FINAL DRAINAGE LETTER FOR LOT 3 OF CLAREMONT BUSINESS PARK 2 FILING NO. 1

Project #44-037
PCD – SP 20-000

RE: Drainage Letter for Lot 3 of Claremont Business Park 2 Filing No. 1

TRIANGULAR RIP-RAP RUNDOWN
NTS

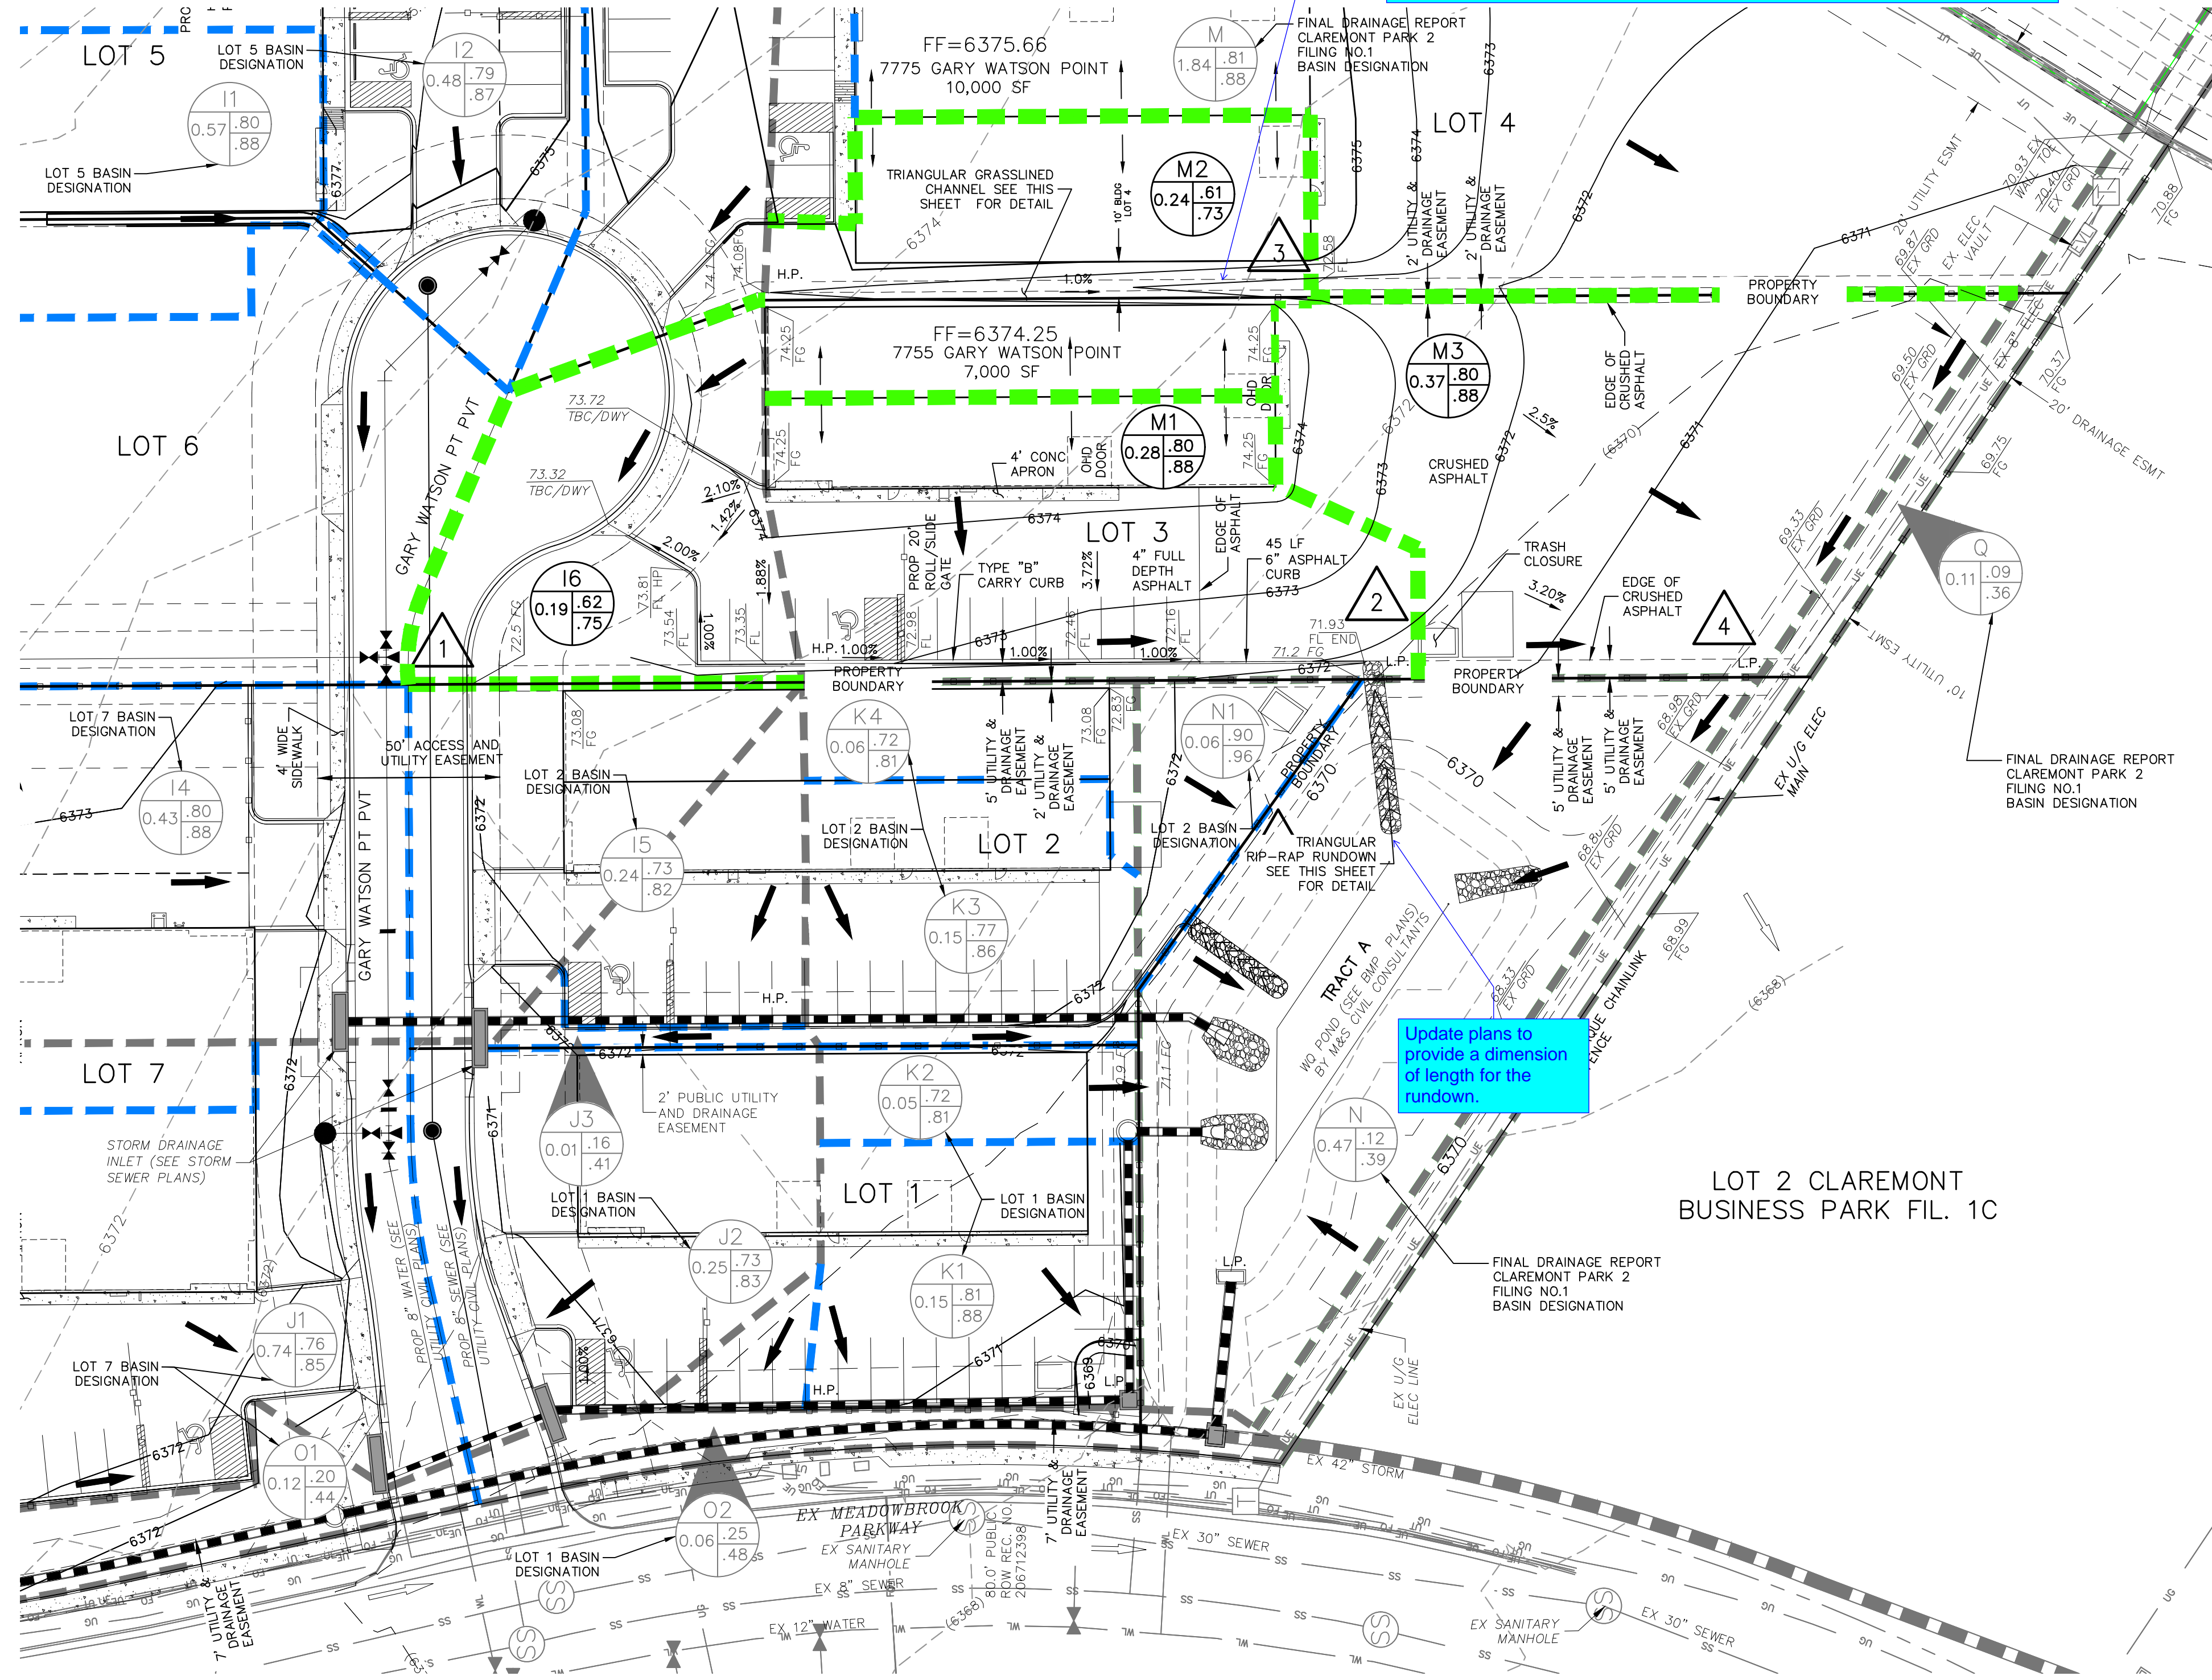
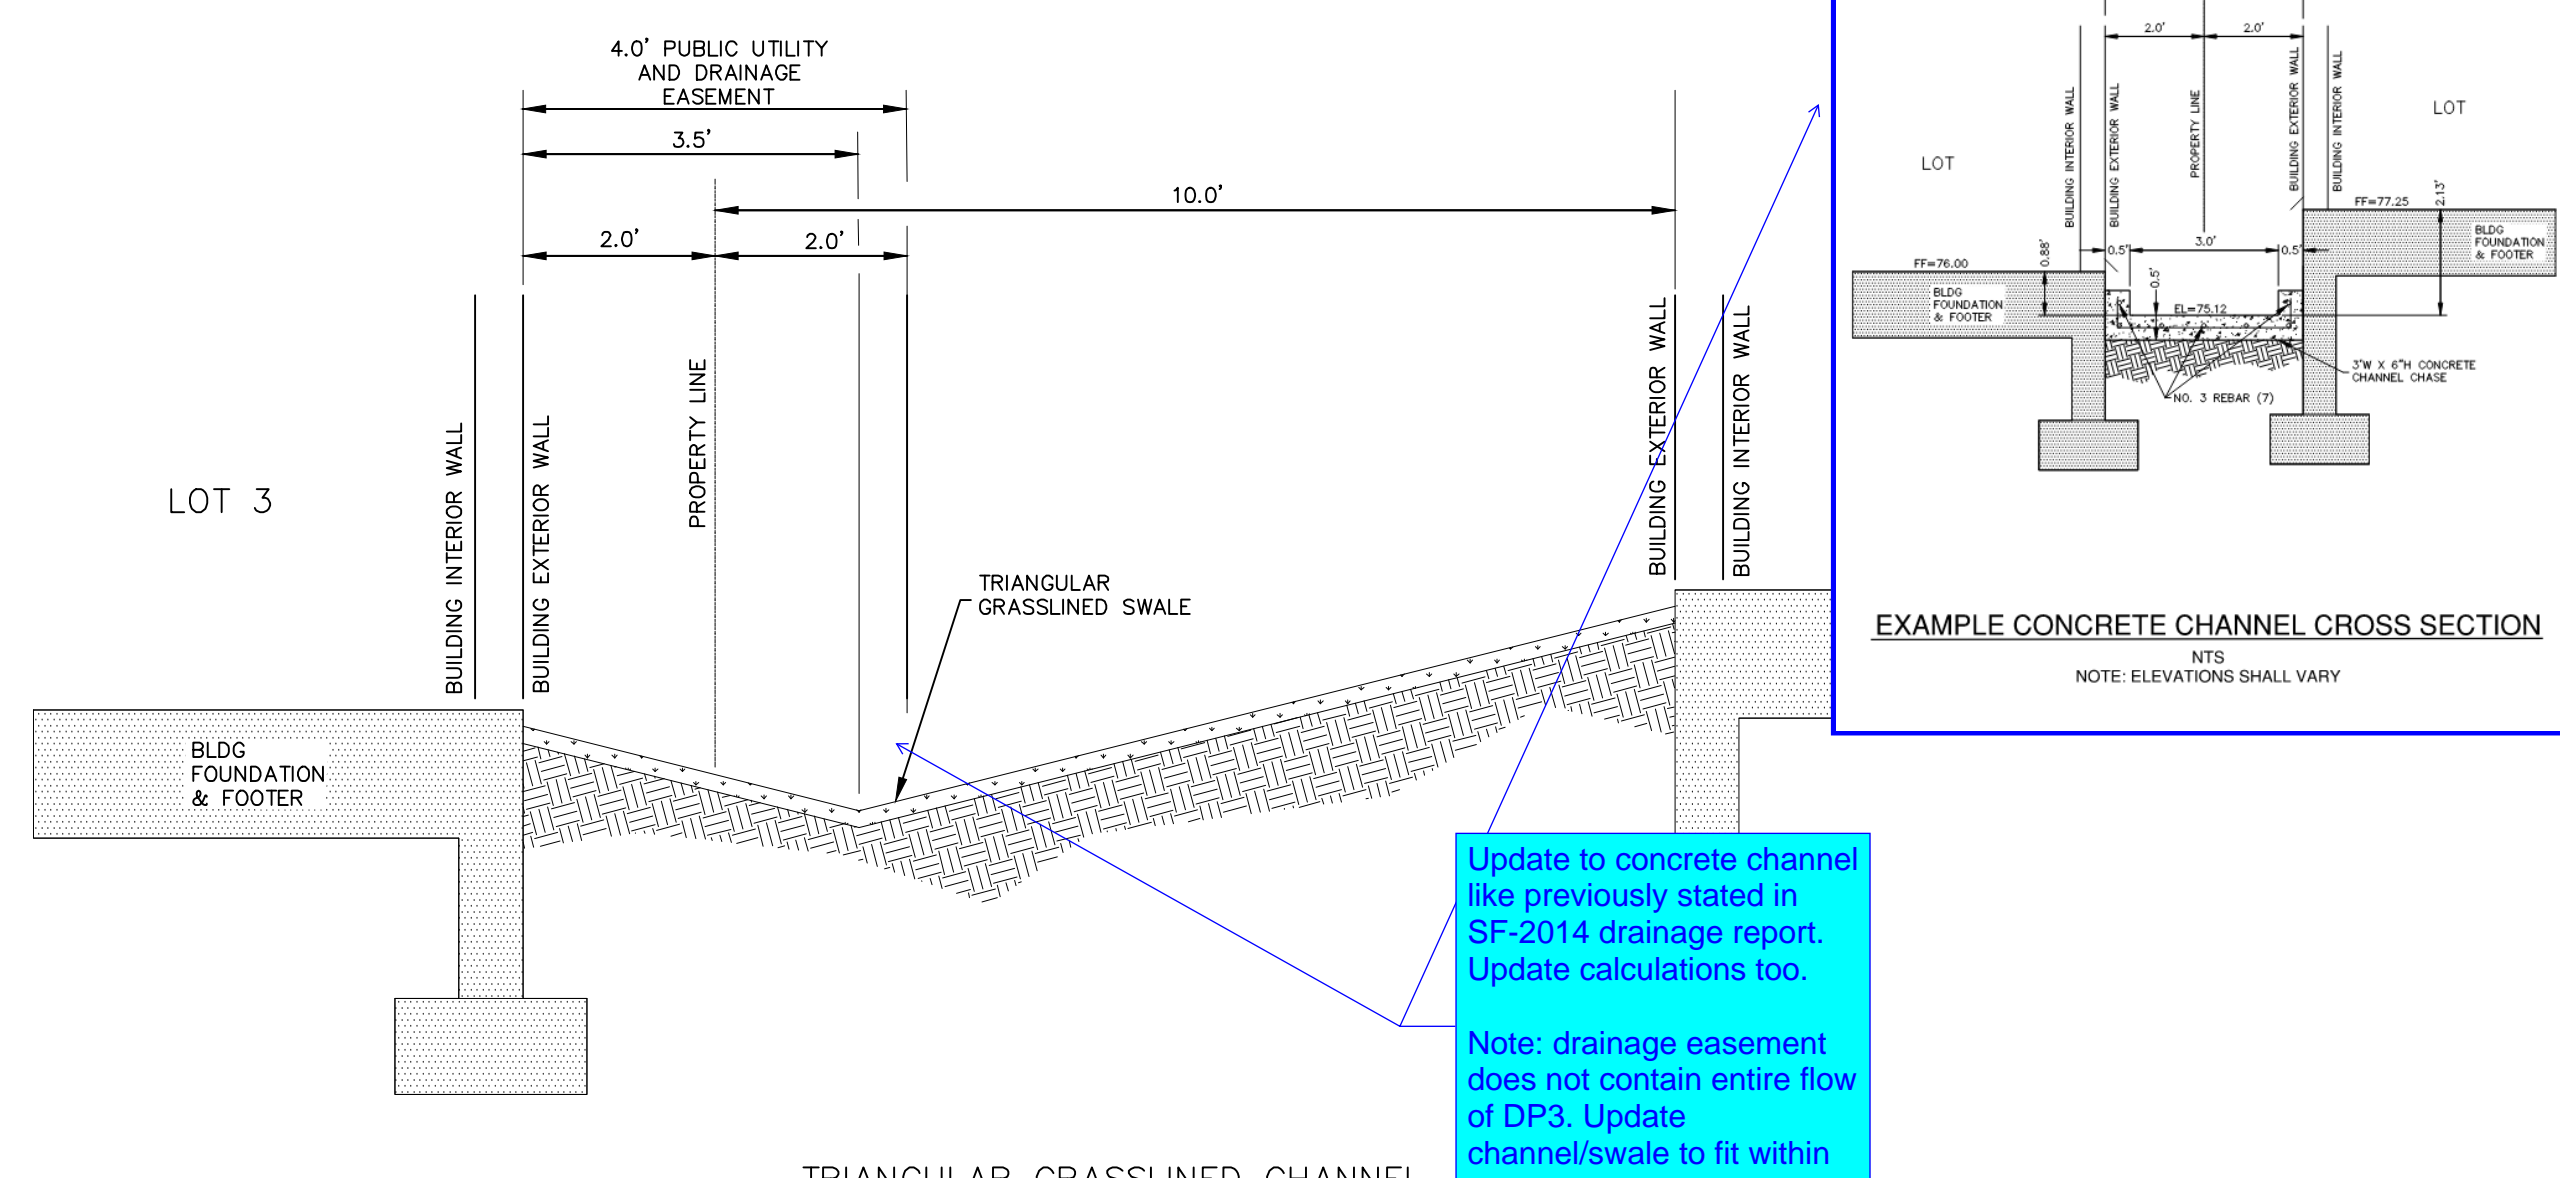
This is meant to be a concrete channel per SF-2014 drainage report. Revise to be in compliance with original report, or redesign grass swale to have water levels within drainage easement.

Update plans to provide a dimension of length for the rundown.

Update to concrete channel like previously stated in SF-2014 drainage report. Update calculations too.
Note: drainage easement does not contain entire flow of DP3. Update channel/swale to fit within drainage easement.
